IRRARAINEZ® SERVICE BULLETIN		Date:	15-May-2003	Model SR9200/SR8200
		Page:	1/1	REF.NBR:MZ03-010
		Subject:		
Circulation:	Application:	Sound cut a little at the beginning of the track  Volume level will decrease when changed Digital and  Analog input		
x for information customer complaint in case of service mandatory	ALL			
		Int.ref:

SERVICE BULLETIN		Date:	15-May-2003	Model SR8200,SR9200
		Page:	1/1	REF.NBR:MZ02-040
		Subject:		
Circulation:	Application:	VOL Level and Tune preset memory aren't Back up		
x for information customer complaint in case of service mandatory	Before			
		Int.r	ef:

SERVICE BULLETIN		Date:	22-Apr2004	Model: SR8200, SR9200
		Page:	1 / 1	REF.NBR: MZ04-034
		Subject:		
Circulation:	Application:	After specific operation, SETUP sometimes returns to initial setting.		
x for information customer complaint in case of service mandatory	ALL	Int.ref:

service bulletin		Date:	15-May2003	Model: SR8200,SR9200
		Page:	1 / 1	REF.NBR: MZ02-030
		Subject:		
Circulation:	Application:	The problem that the sound of Dolby Digital is Interrupted.  Int.ref:		
x for information customer complaint in case of service mandatory	See Below

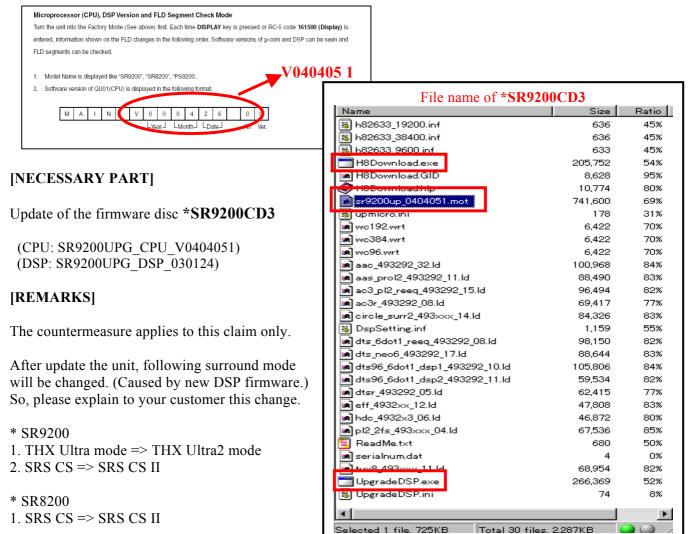
- 1. By SETUP MENU, Set the Speaker level of SURROUND to "+1dB or more". Then, escaping from MENU.
- 2. The Sound level is set to "negative infinity" from "other than negative infinity" by VOL Knob
- 3. Press the POWER switch to turn off and turn on,
- 4. "Clear memory" is displayed and SETUP sometimes returns to initial setting.

- 1) Update the CPU's software version to [ V0404051 ]
- 2) Update the DSP's software.
